STAFF RECOMMENDATION 1925 19th Avenue South July 17, 2019

Application: New Construction—Addition; Partial Demolition
District: Belmont-Hillsboro Neighborhood Conservation Zoning Overlay
Council District: 17
Map and Parcel Number: 10412017000
Applicant: Hunter Conley, Allard Ward Architects
Project Lead: Melissa Sajid, melissa.sajid@nashville.gov

Description of Project: The application is for a rear addition that extends two feet (2') taller than the historic house. The plan also includes demolition of an existing screened porch and partial demolition of an existing window opening on the left side façade of the historic house.

Figures 2 and 3. 1951 Sanborn map and current footprint per the Property Assessor

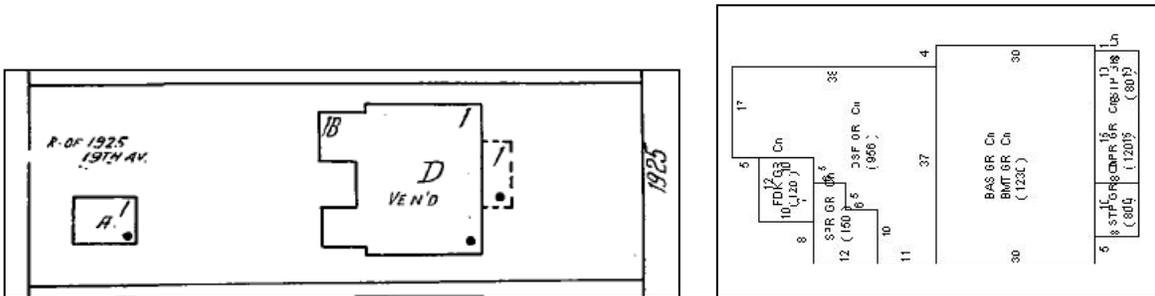
Partial demolition: The application proposes to demolish an existing screened porch. When comparing the existing footprint to the 1951 Sanborn map, it is evident that the rear has been altered over time and that the existing screened porch is not likely original (Figures 2 and 3). For this reason, staff finds it appropriate to demolish the existing screened porch.

Figure 5. Proposed left side façade

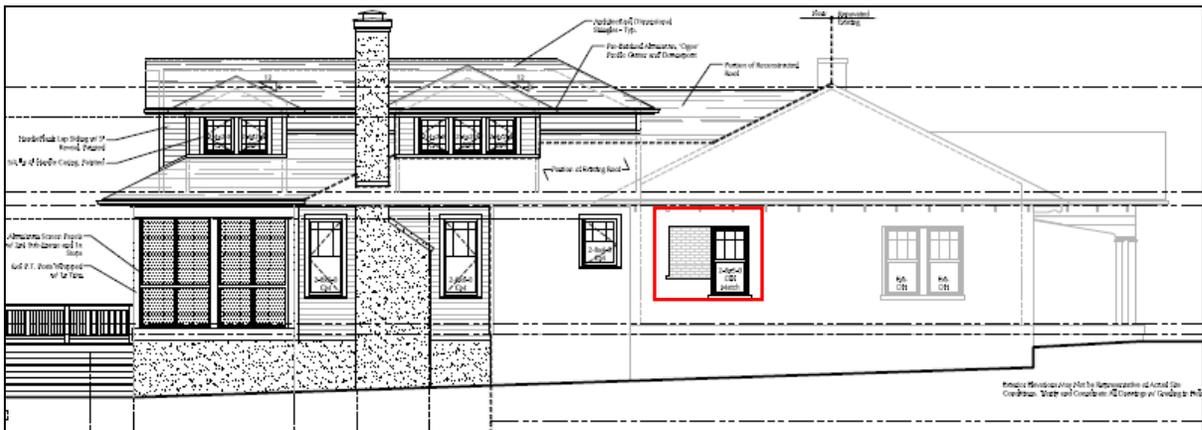
The applicant also requests to replace the short, paired windows on the rear of the left side façade with a vertically oriented single, double-hung window (Figures 4 and 5). Staff finds proposed window alteration to be appropriate given its location on the side façade beyond the midpoint. In addition, the new window opening will be in the same area as the existing and have an appropriate proportion.

Staff finds that demolishing the screened porch and altering the existing window opening on the left side façade near the rear to be appropriate since the porch and opening are not visible from the public right of way and do not contribute to the historic or architectural character of the overlay.
